REFERENCE CHANGE ORDER #3

**SCHEMATIC PLAN VIEW
AARDOT 247-723Y
MP 6.45
HIGHWAY CROSSING**

NOT TO SCALE	
PROJECT NAME: ESSEX JUNCTION	
PROJECT NUMBER: NH 2956(2)	
FILE NAME: z15v026rrschp.dgn	PLOT DATE: 4/19/2016
PROJECT LEADER: D.GOZALKOWSKI	DRAWN BY: C. KAHLBAUGH
DESIGNED BY: M. MOKEY	CHECKED BY: D. EMERICH
AARDOT 247-723Y RAILROAD PLAN VIEW	SHEET 165 OF 171

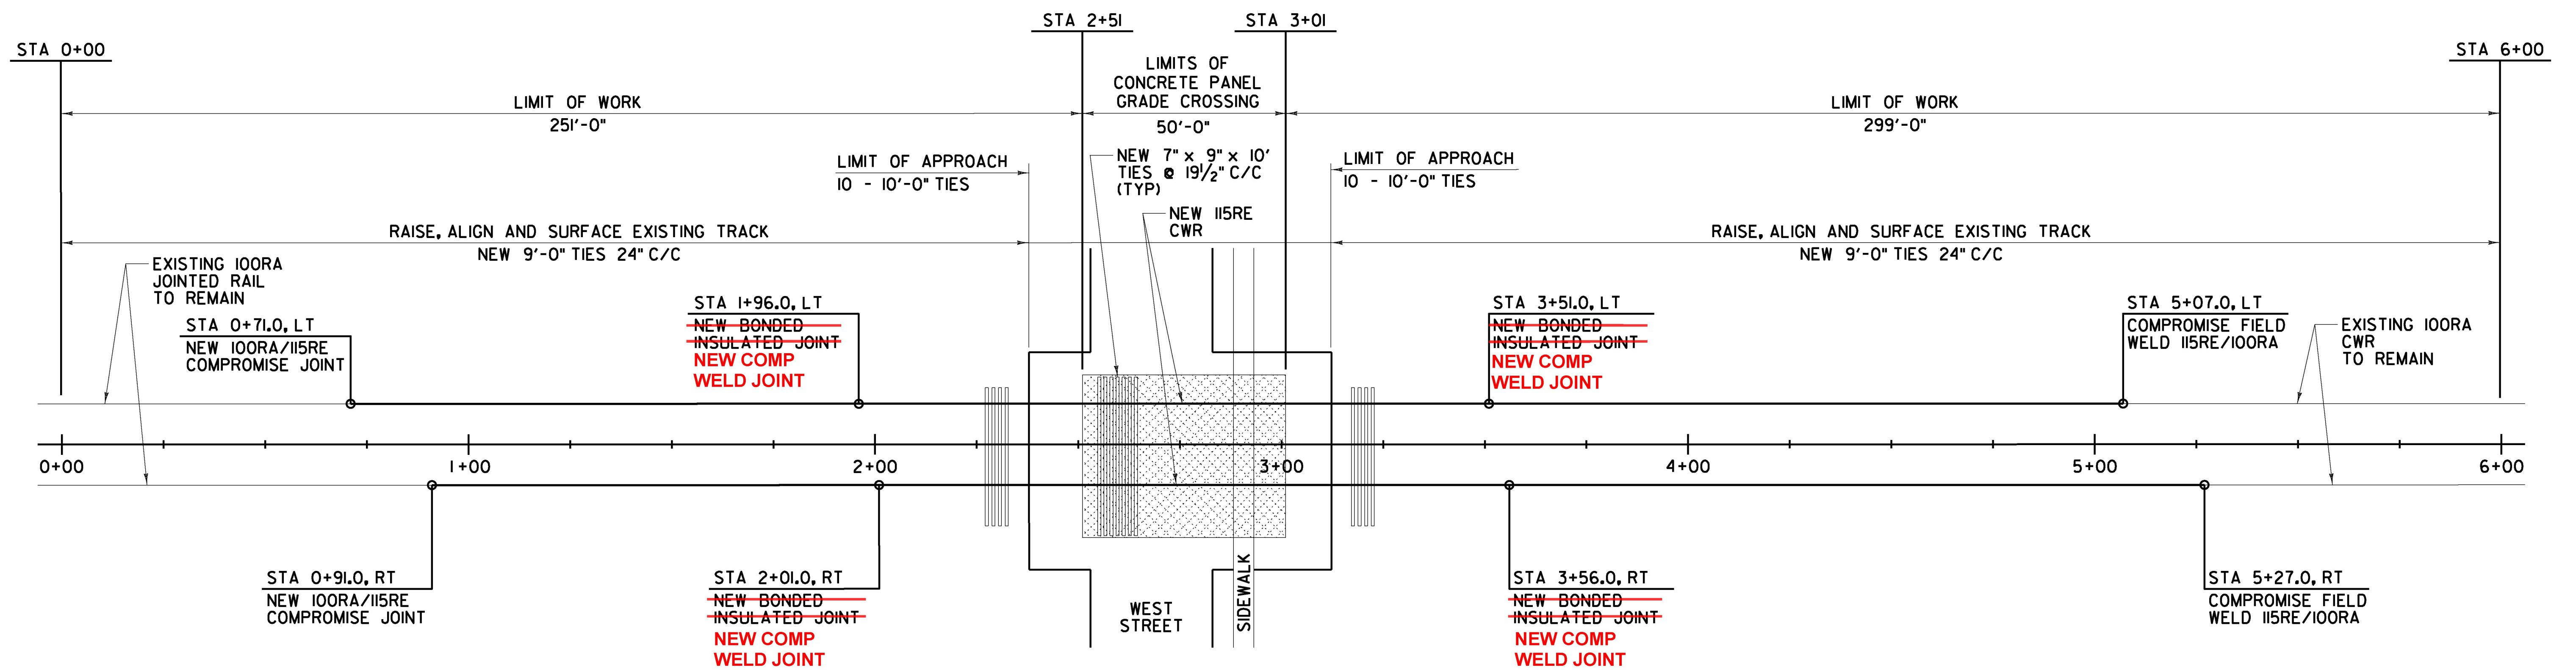
Robert Hensel, Director of Signals & Communications of Genesee and Wyoming Railroads (GWRR) an affiliate of New England Central Railroad (NECR), notified Resident Engineer Josh Hulett on June 16, 2017 that a "...PMD3 was used at the West Street Extension crossing and did not require insulated joints for this style of circuit." Ron Bocash, VP Signal & Train Control, GWRR, confirmed this in an email dated June 20, 2017 to Resident Engineer Hulett and Alan Clark of FWW that, "...insulated joints are not required at MP 6.45 West Street. Circuits are motion sensor only." Rick Boucher of GWRR noted (via email) on July 28, 2017 that, "...they (GWRR) preferred that these (joints) were Comp weld vs. Comp Bar.
